AGENDA
CASCADE CHARTER TOWNSHIP PLANNING COMMISSION
MONDAY, June 3, 2024
7:00 PM
2870 JACKSMITH AVE SE

- ARTICLE 7. Case #24-3844 Public Hearing**
2024 Master Plan Public Comment Review & Recommendation
Applicant: Cascade Charter Township
Requested Action: Recommend Adoption of Master Plan
by Township Board

- ARTICLE 8. Case #24-3830**
Applicant: Mollers North America, Jon Frego
Property Address: 5215 52nd St SE
Parcel Number: 41-19-30-400-009
Requested Action: Site Plan Review for expanding an
existing warehouse 5,515sqft and adding a driveway
entrance.

- ARTICLE 9. Case #24-3834**
Applicant: FCC, Inc., Byrne Harmon
Property Address: 5725 & 5755 52nd St SE
Parcel Number: 41-19-29-300-019, 41-19-29-300-029
Requested Action: Site Plan Review for a new 110,000 sf industrial building.

SHEET NUMBER: C1
 TOPOGRAPHIC, BOUNDARY SURVEY & REMOVALS

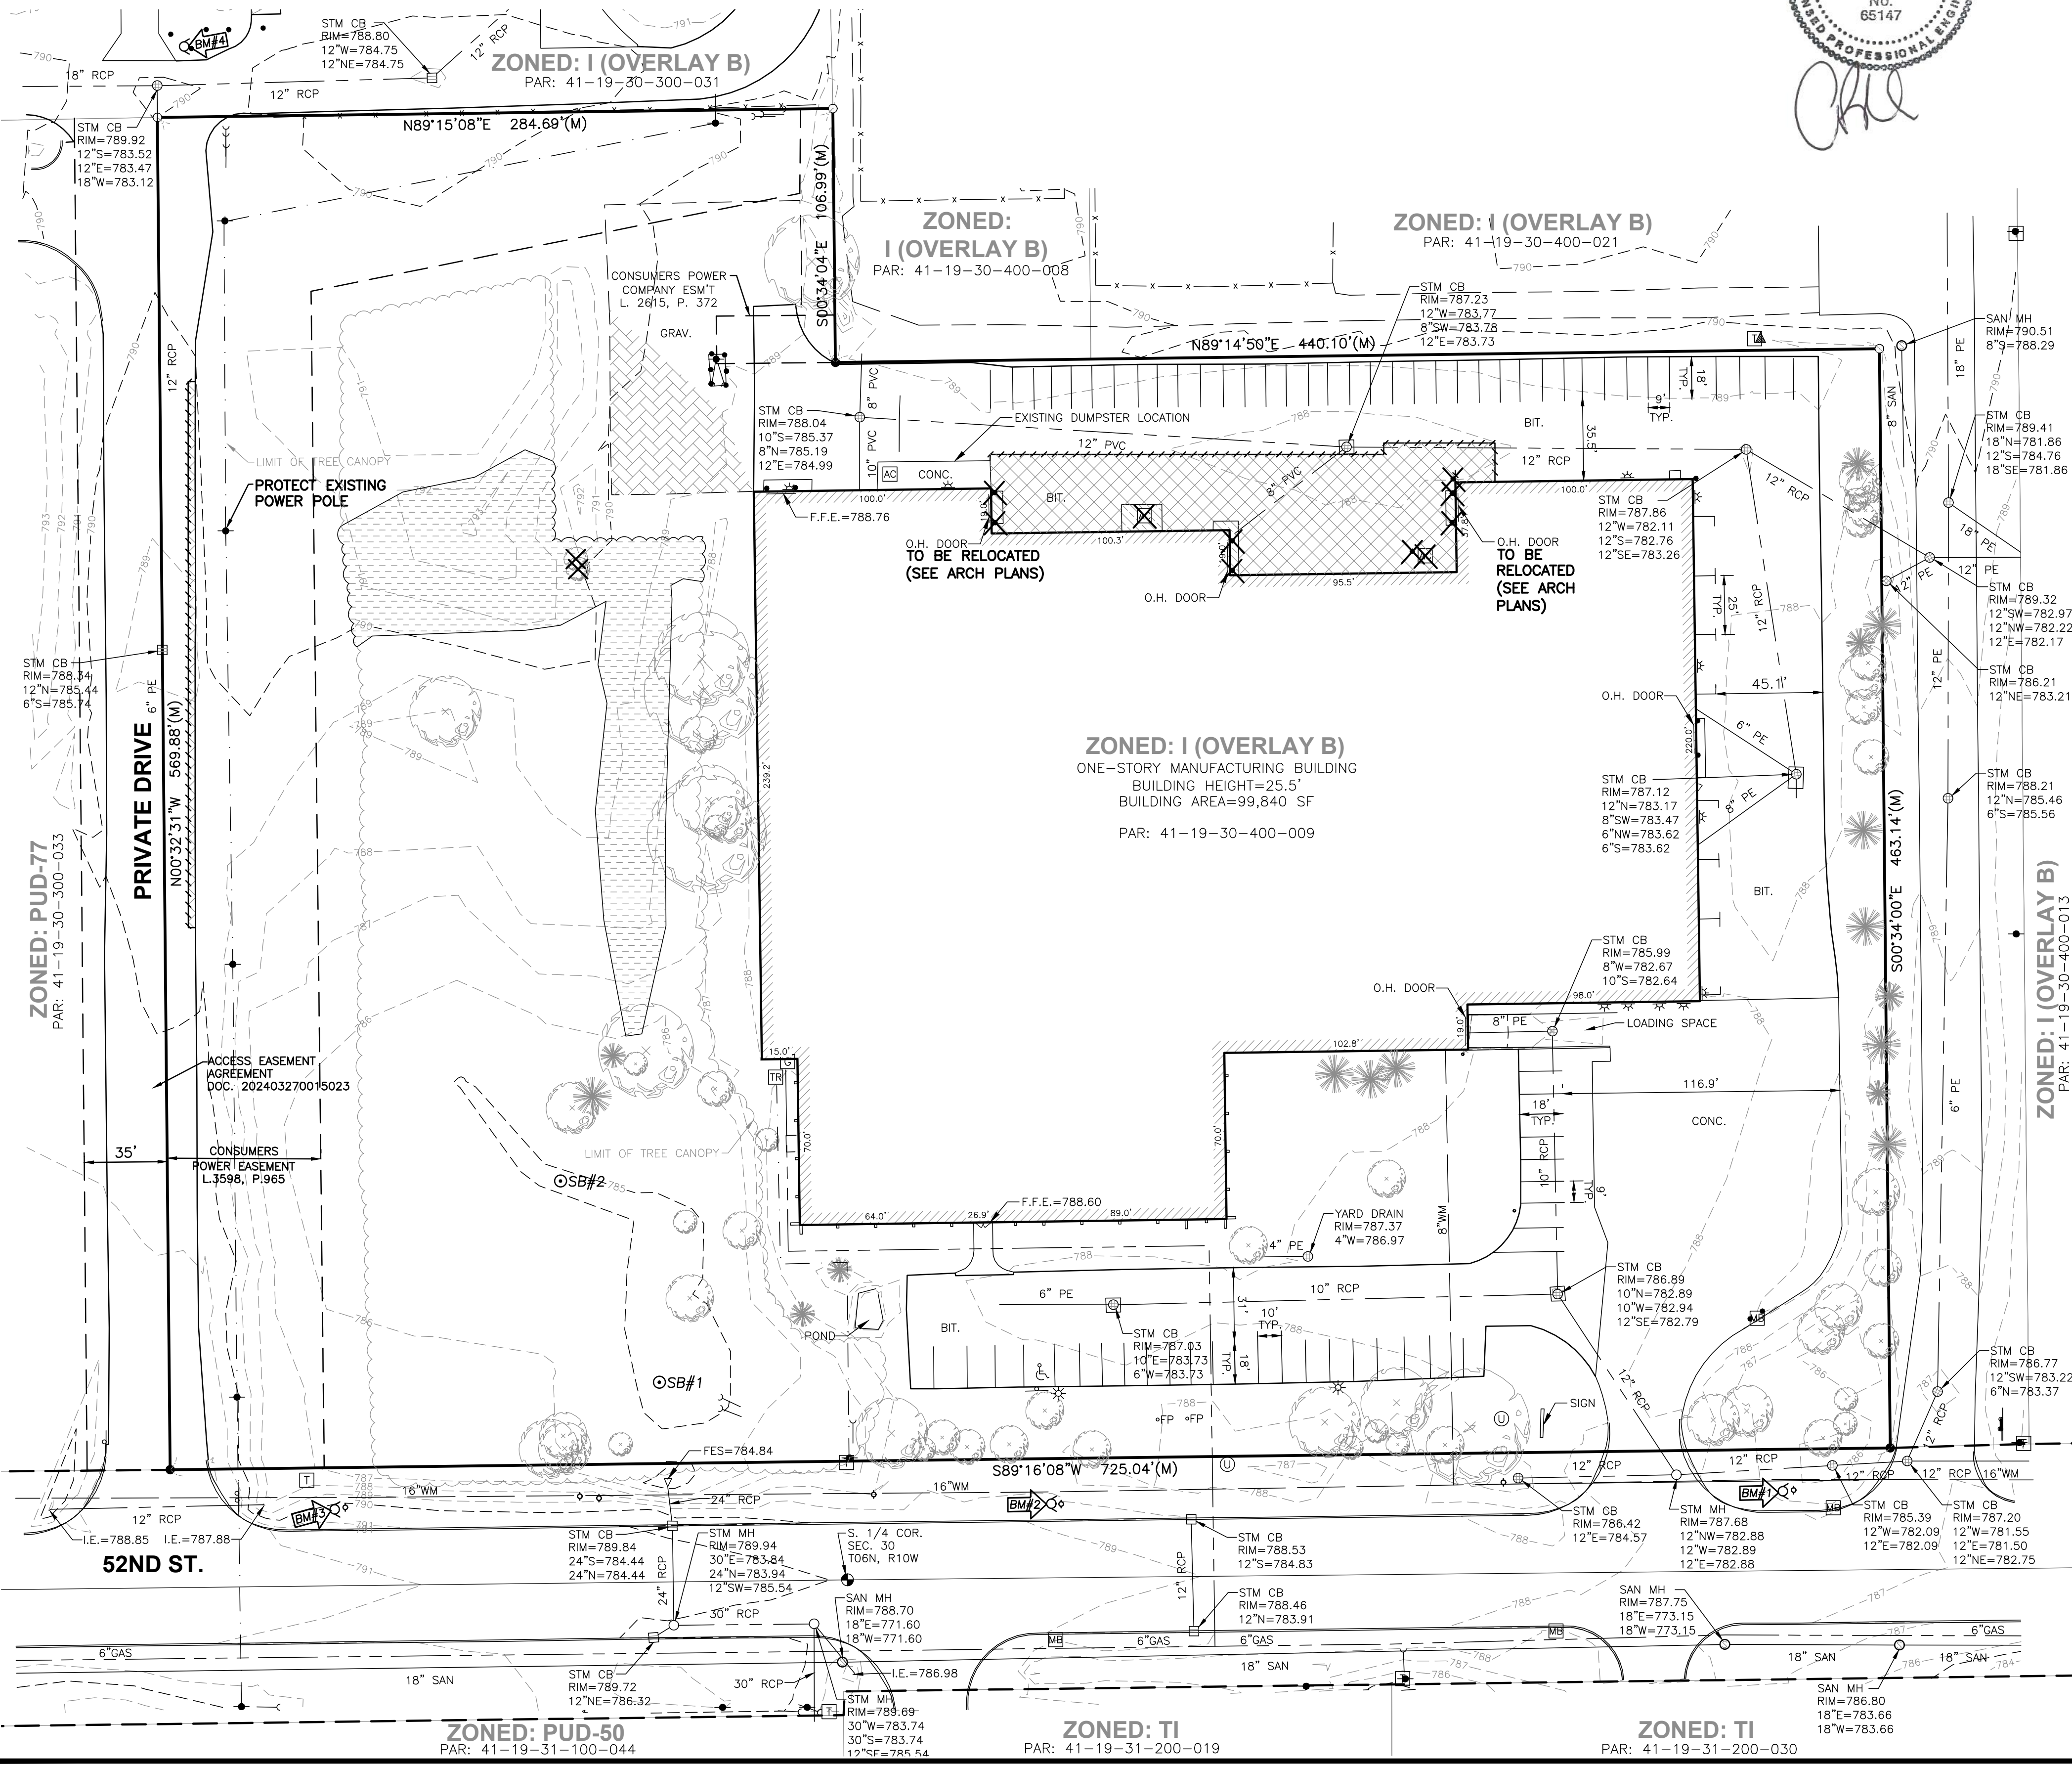
Two soil borings (hand augers) were completed on the site and are included in the submittal. The hand augers were completed on May 20, 2024 by Soils and Structures of Norton Shores, Michigan. The soil borings indicate the underlying soils are mostly clay, with elevated groundwater. The soil borings are provided in this submittal and are also shown on sheet C1 of the site plans.

05/29/24	REV PER PLANNING DEPARTMENT	MK	DRAWN BY: MK	APPROVED BY: JPM	PROJ. ENG.: DJS	SHEET
	REVISION	BY	FILE NO.: 191068E	DATE: 04/18/24		1 of 3

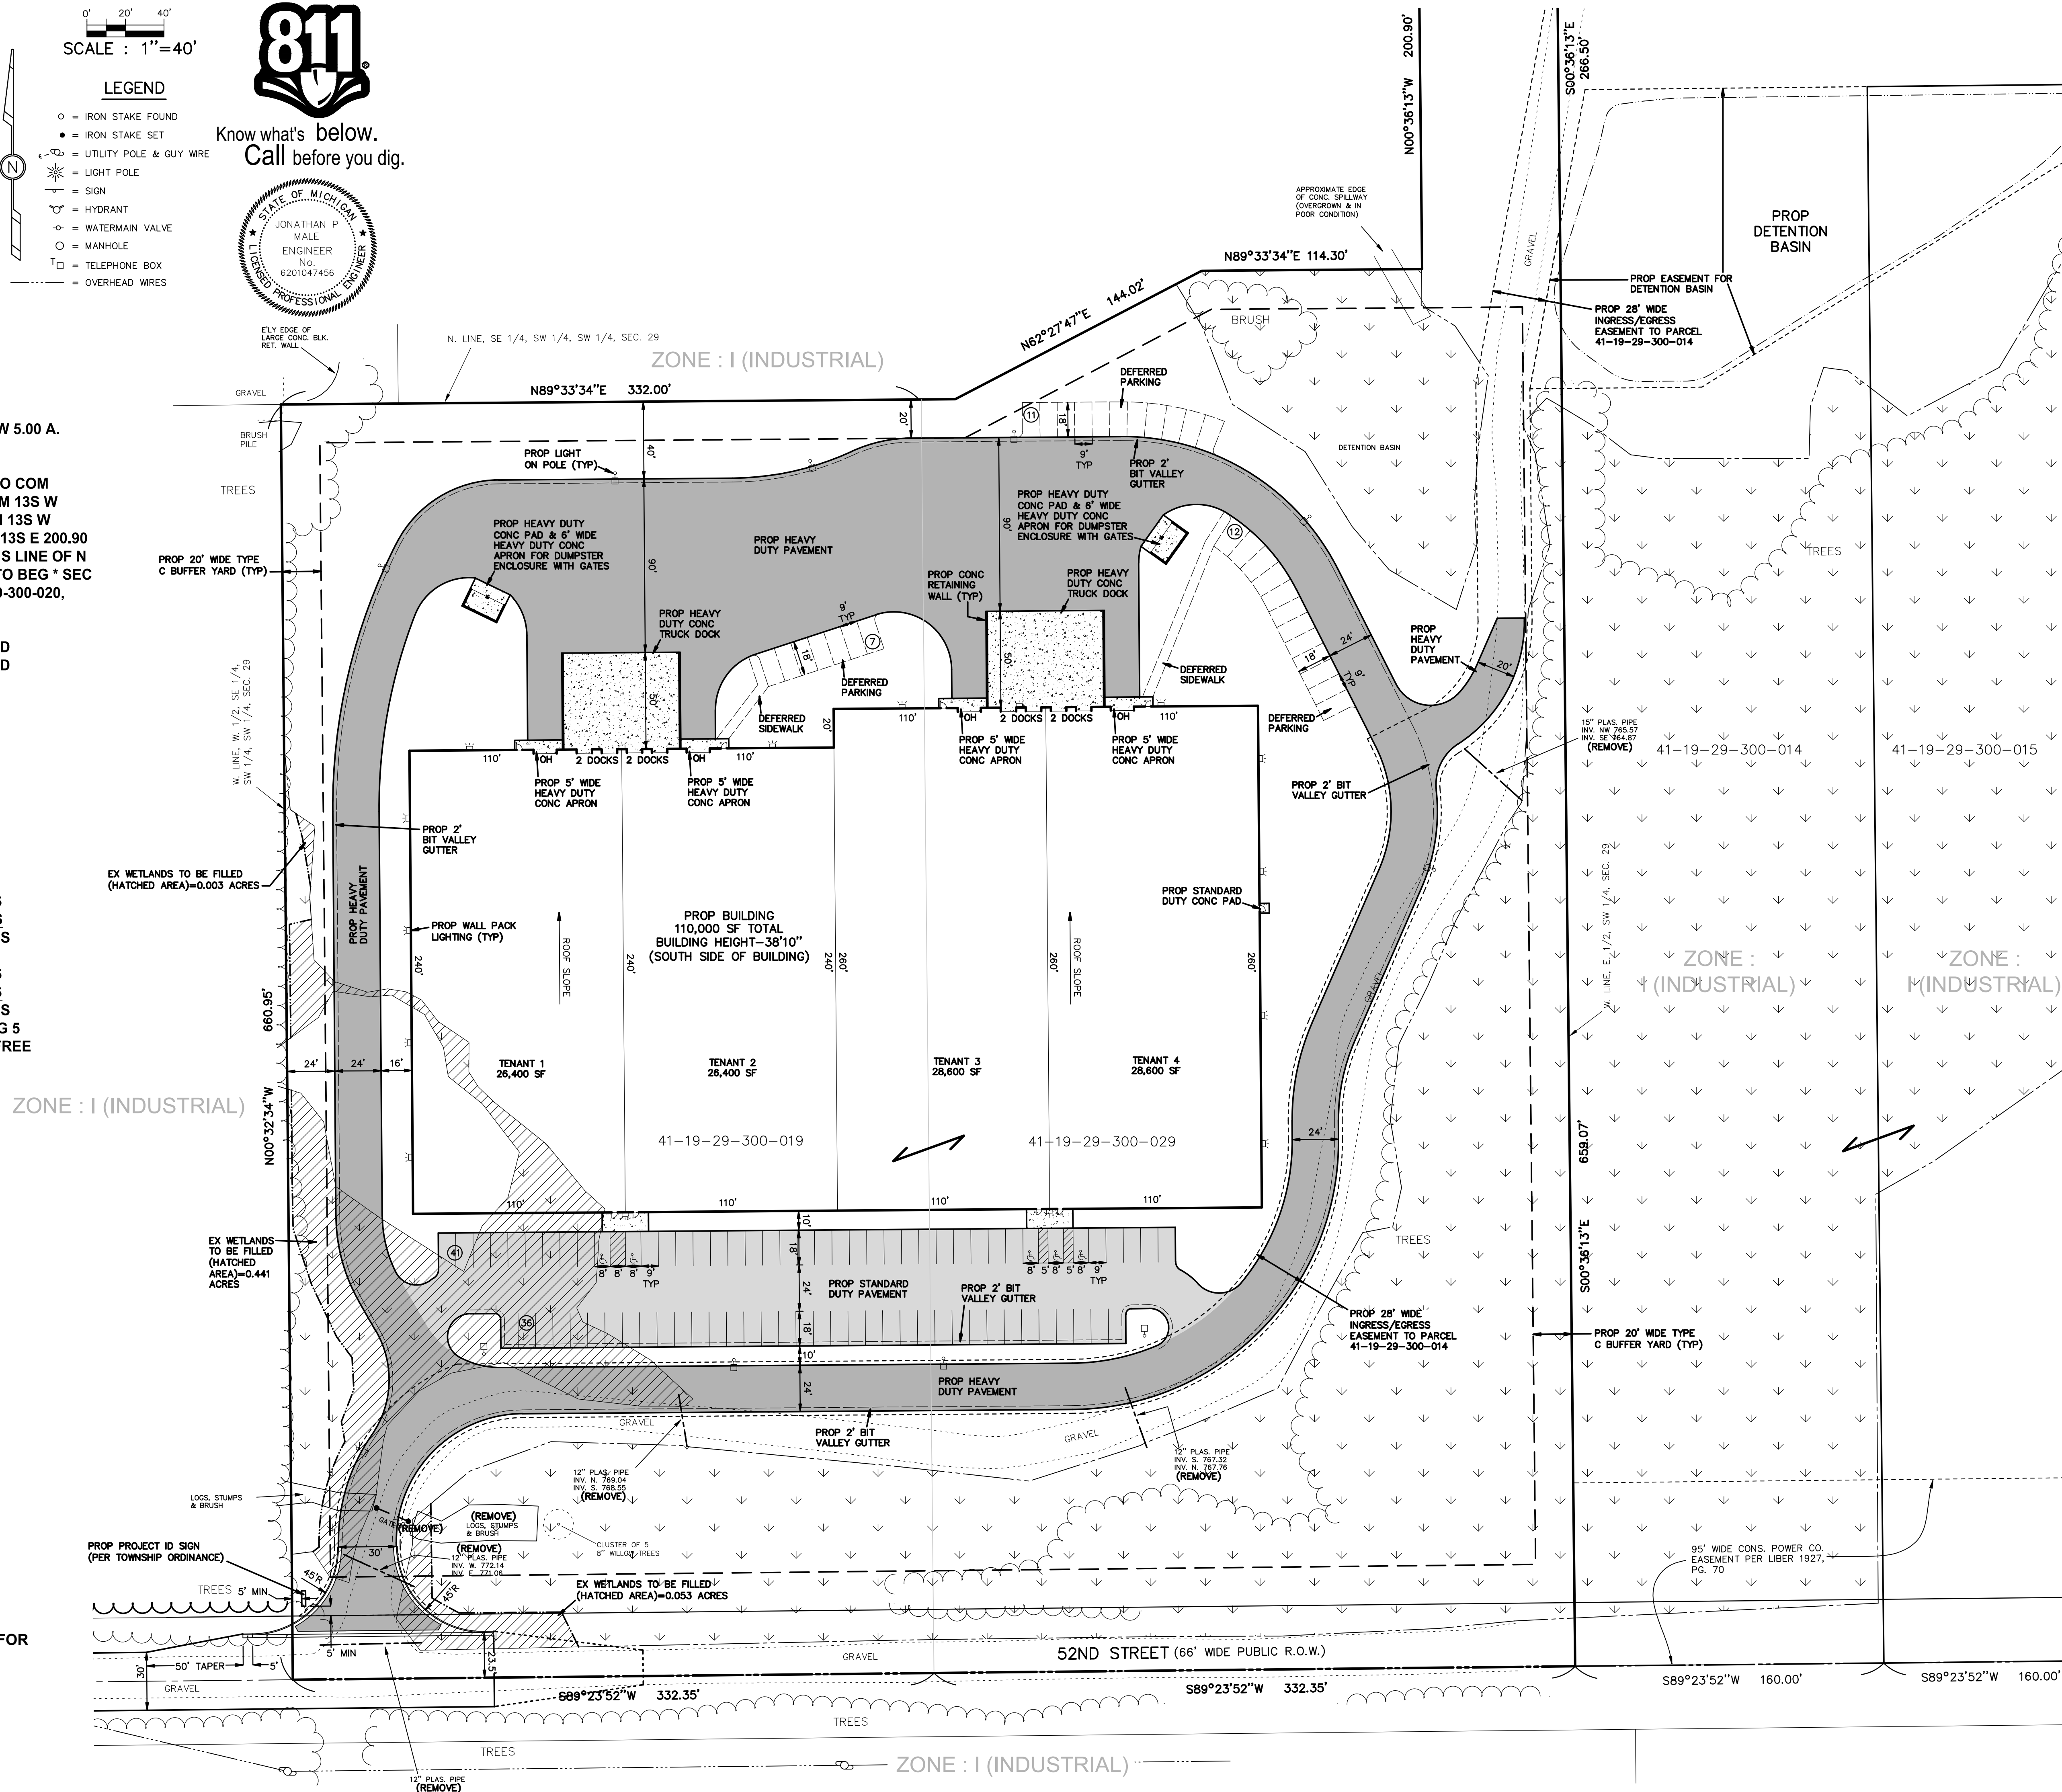
The proposed industrial is surrounded by industrial zoned properties on all sides. Therefore, the development would require the Type C Bufferyard standards. The applicant has indicated the location of the required buffer yard on the Site Layout Plan dated 5/29/2024 (Sheet 1 of 3), however the applicant has not provided any plant material.
